Access Compliance Report

Public Rights-of-Way

Intersection ID: 3921	Main Street: CHILCOMB_CT	Cross Street: COPPERPLATE_RD	Location: NW
ADA ID: DB5D1E99B68F	Ramp Type: Perp	Initial Pass/Fail: Fail	Overall Compliance: No
		Severity Score: 12.5

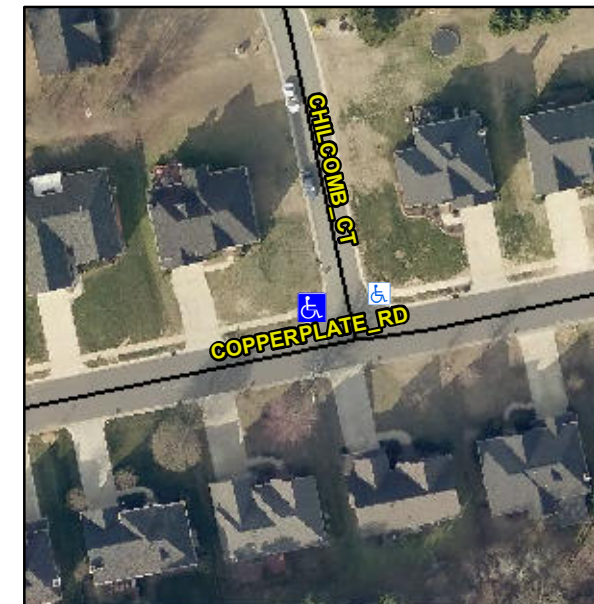
Not Found, R304.5.3

Compliance	Description	Data	Compliance	Description	Data
N/A	Ramp Length (in)	48.0	Yes	Ramp Slope (%)	5.0
Yes	Ramp Width (in)	51.0	No	Ramp XSlope (%)	6.4
N/A	Flare Type LT	N/A	N/A	Flare Type RT	N/A
N/A	Flare Slope LT (%)	N/A	N/A	Flare Slope RT (%)	N/A
N/A	Flare Traversable LT?	N/A	N/A	Flare Traversable RT?	N/A
N/A	Landing Length (in)	N/A	N/A	DWS Provided?	N/A
N/A	Landing Width (in)	N/A	N/A	DWS Contrast?	N/A
N/A	Landing Slope (%)	N/A	N/A	DWS Length (in)	N/A
N/A	Landing X Slope (%)	N/A	N/A	DWS Full Width?	N/A
N/A	Landing Curb? (Y/N)	N/A	N/A	DWS Offset (in)	N/A
N/A	Shared Landing?	N/A			
N/A	Gutter Ponding?	N/A	N/A	Gutter Slope (%)	N/A
N/A	Gutter Lip Ht (in)	N/A	N/A	Gutter X Slope (%)	N/A
N/A	Painted X Walk1?	No	N/A	Painted X Walk2?	N/A
	X Walk 1 Direction	To E		X Walk 2 Direction	N/A
N/A	X Walk 1 Width (in)	N/A	N/A	X Walk 2 Width (in)	N/A
	X Walk 1 Slope (%)	5.6		X Walk 2 Slope (%)	N/A
	X Walk 1 X Slope (%)	2.3		X Walk 2 X Slope (%)	N/A

Remove & Replace Entire Ramp.
